Gallup Ay 2011 ENTERED WWTS / STP-1 pond

From: Chavez, Carl J, EMNRD
Sent: Tuesday, August 16, 2011 11:14 AM
To: Chavez, Carl J, EMNRD; Hains, Allen
Cc: Riege, Ed; VanHorn, Kristen, NMENV; Cobrain, Dave, NMENV; VonGonten, Glenn, EMNRD
Subject: RE: engineering drawings STP-1

From: Riege, Ed [Ed.Riege@wnr.com]
Sent: Friday, August 19, 2011 9:48 AM
To: Chavez, Carl J, EMNRD; VanHorn, Kristen, NMENV
Cc: Keys, Frank; Hains, Allen; Riege, Ed
Subject: FW: STP-1 Response to Questions
Attachments: 20110818111843924.pdf

Approximate Not to Scale	SITE PLAN Boring Locations (approximate) GEOMAT Project No. 112-1286 Date Borings Drilled: 04-11-11 to 04-13-11	PROJECT Waste Water Treatment Plant Gallup Refinery Gallup, New Mexico

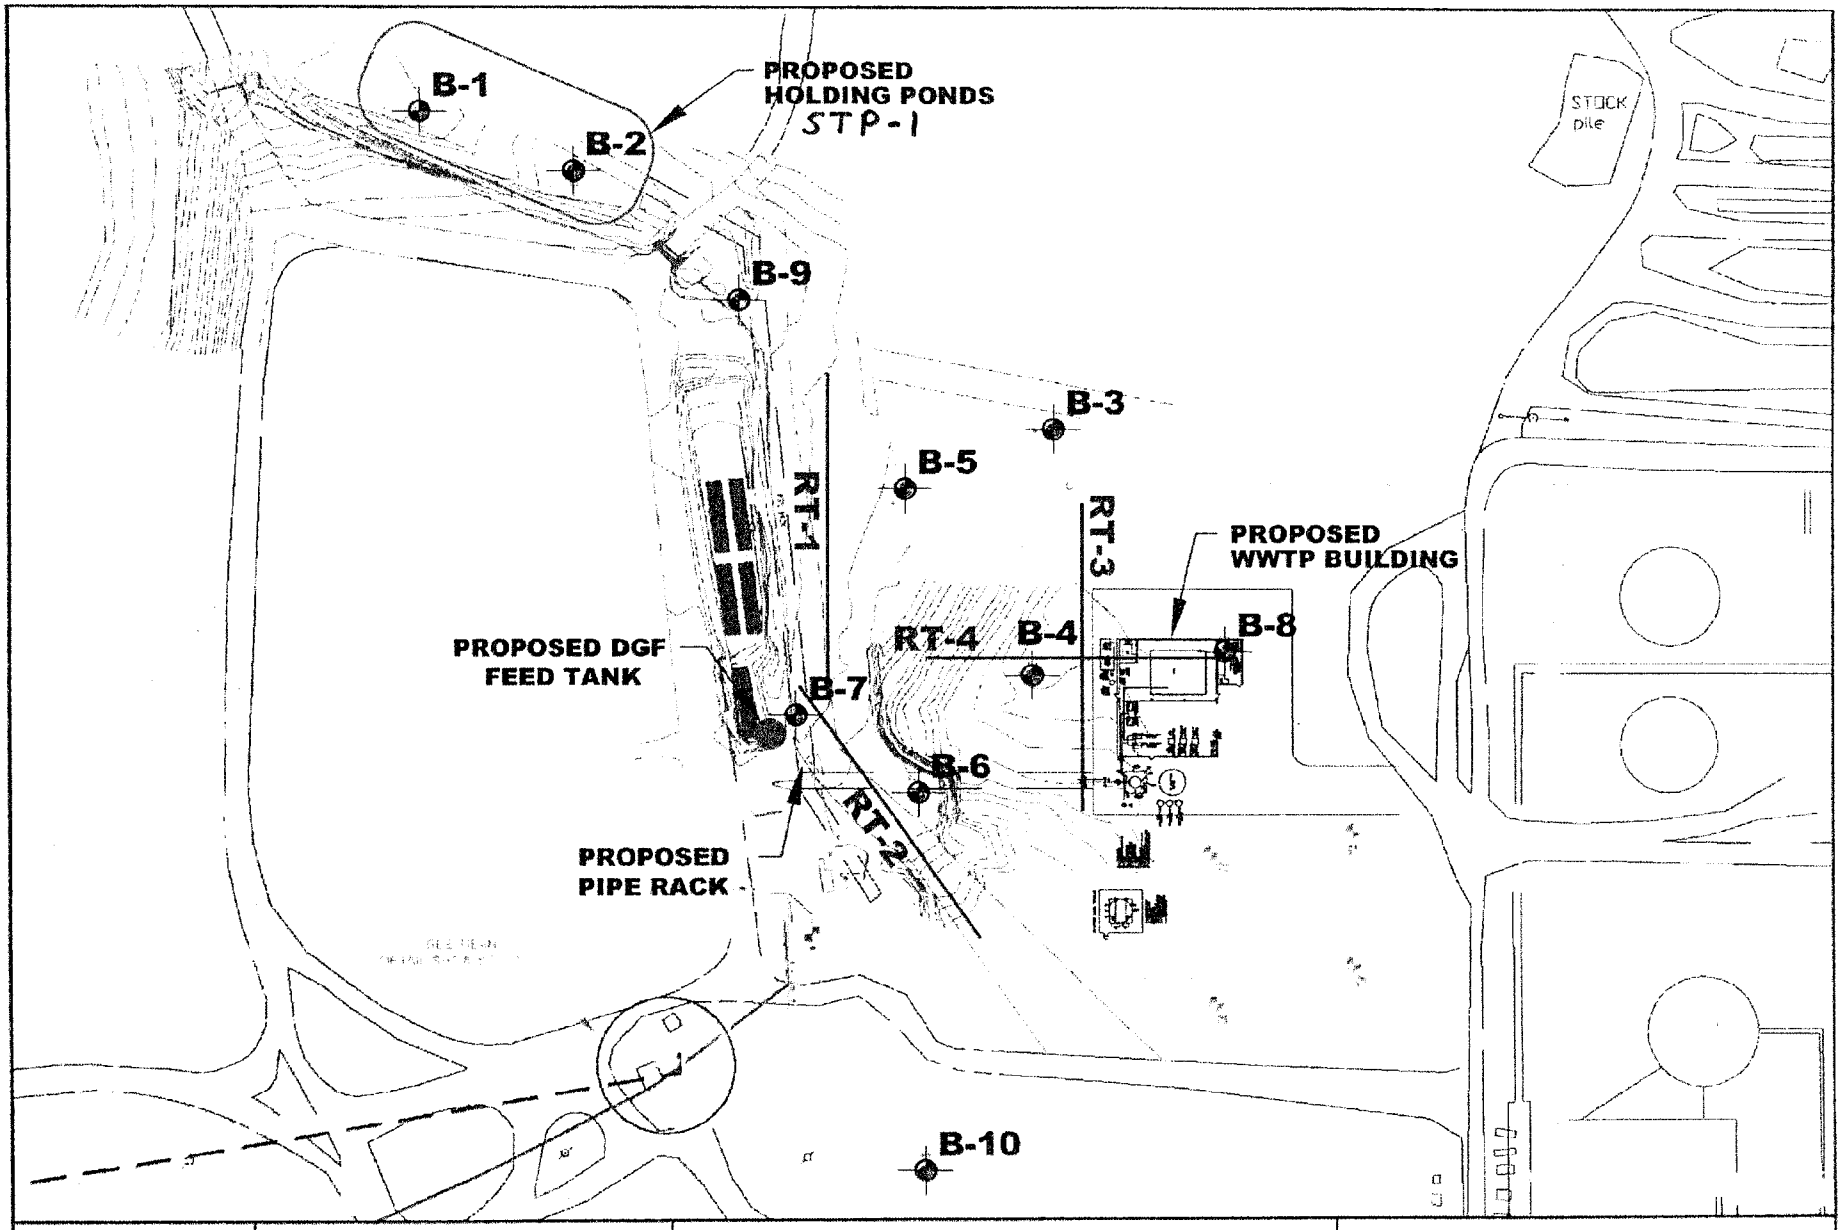
3. Were any geotechnical borings done at the site? Where are the logs and the geotechnical results?
4. What is the outflow pipe (to EP-2) covered in to ensure no freezing? Is the pipe above ground or subgrade? Where will sample port(s) be for the outflow of the pipe as it enters EP-2?

3. Were any geotechnical borings done at the site? Yes Where are the logs and the geotechnical results? Our geotechnical investigation included two boreholes at STP-1, see Attachment 3.
